CITY OF TORONTO DESIGN REVIEW PANEL MINUTES: MEETING 4– May 18, 2017

1779-1791 ST CLAIR AVE WEST

DESIGN REVIEW	First Review
APPLICATION	Site Plan Approval
DEVELOPER	Graywood Developments
<i>PRESENTATIONS:</i>	
DESIGN TEAM	SMV Architects – Dan Cowling; Strybos Barron King – Bryn Barron
CITY STAFF	Anthony Hommik, Community Planning; Allison Reid, Urban Design
VOTE	Redesign - Unanimous

101 SPADINA AVE

Side Elevations

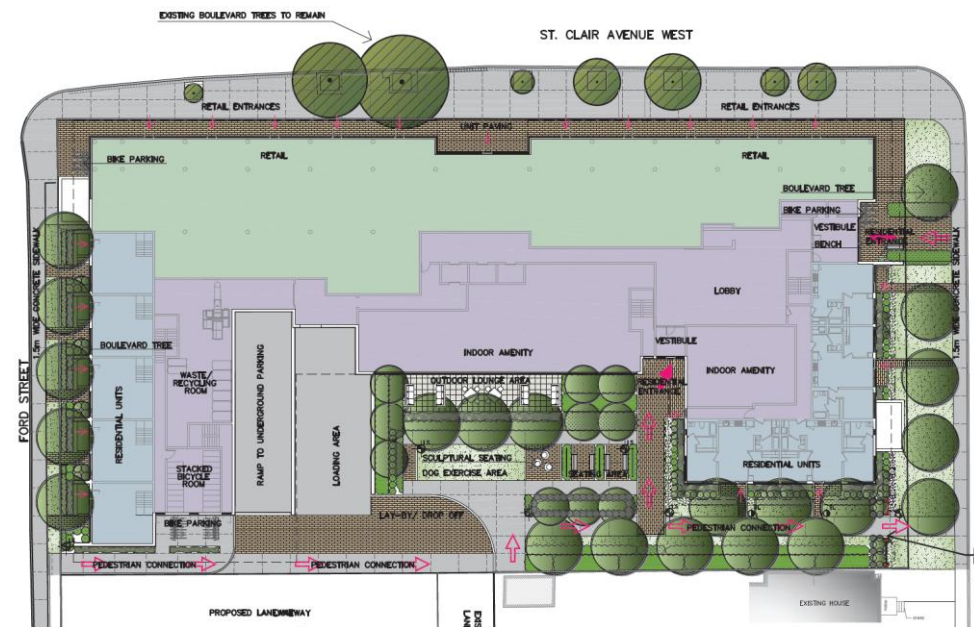
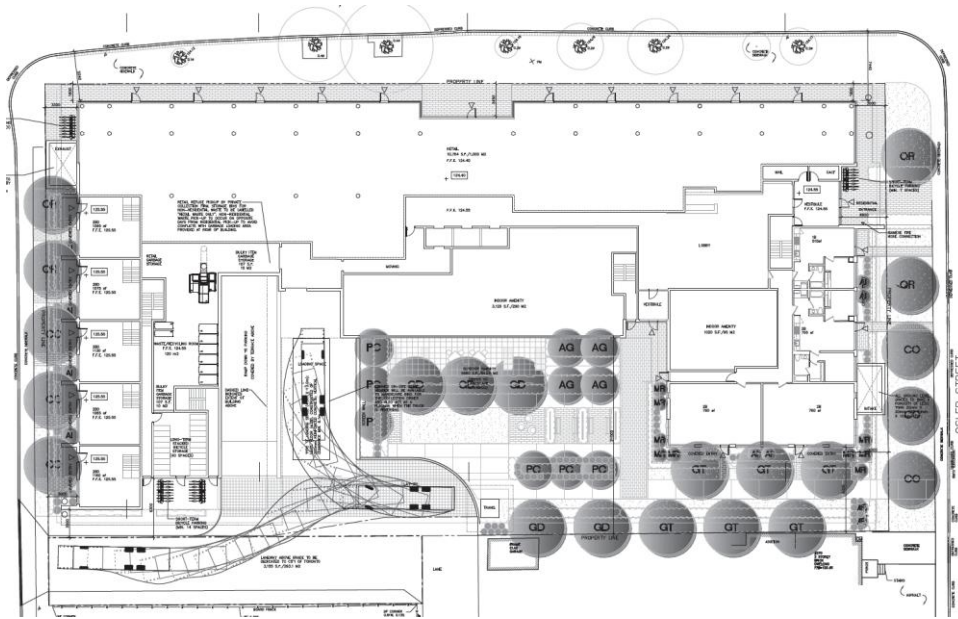
Several Panel members noted that the elevations on the side streets were also in need of further articulation development. A Panel member commented that at present, they are "quite strong and foreboding". Another Panel member noted that due to the zoning and mid-rise guidelines, "we get lots of wedding cake buildings" as seen on the proposed west and east elevations, and advised more work on this.

- Consider shading strategies:
A Panel member noted that providing vertical elements on west and east would increase help with shading as well as provide massing opportunities.
